UNITED STATES PATENT AND TRADEMARK OFFICE

APPLICATION NO.	FILING DATE	FIRST NAMED INVENTOR	ATTORNEY DOCKET NO.	CONFIRMATION NO.
09/819,434	03/28/2001	Kiwamu Inui	10873.679US01	2708

Office Action Summary	Application No. 09/819,434	Applicant(s) INUI ET AL.	
	Examiner Carol Chaney	Art Unit 1745

FIG-11

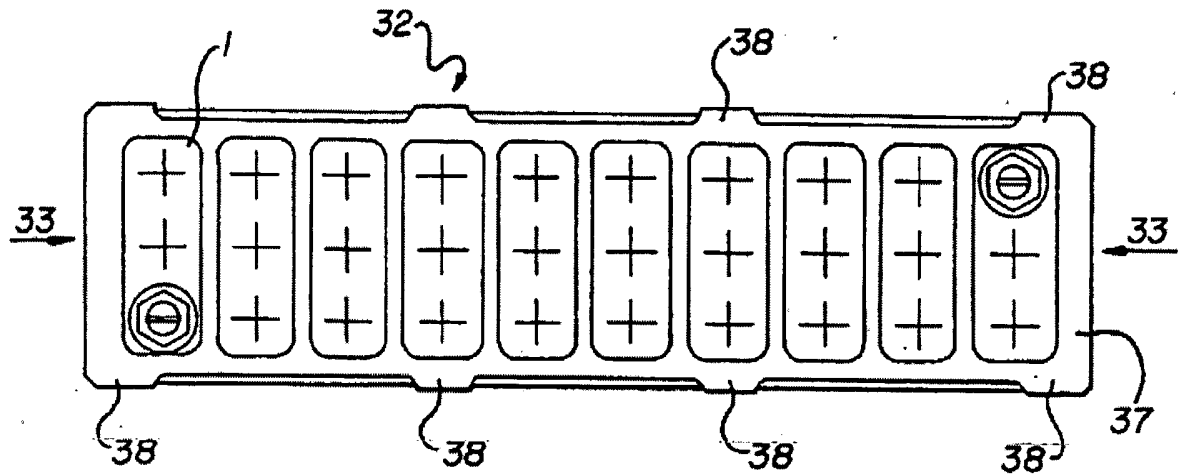
With regards to applicants' claims 7-9, applicants assert Ovshinsky does not teach an arrangement where the battery modules in the battery pack case have a plurality of concave and convex portions on the sides opposed to other battery modules, and when the battery modules are connected by bringing the opposite convex portions into contact with each other, gaps between the battery modules formed by the concave portions act as the coolant flow paths. In response, please note Figures 11, 12 and 15 and page 26, lines 22-32 of the Ovshinsky et al. patent. Module spacers (37) with tabs (38) are placed between battery modules, and form flow channels.
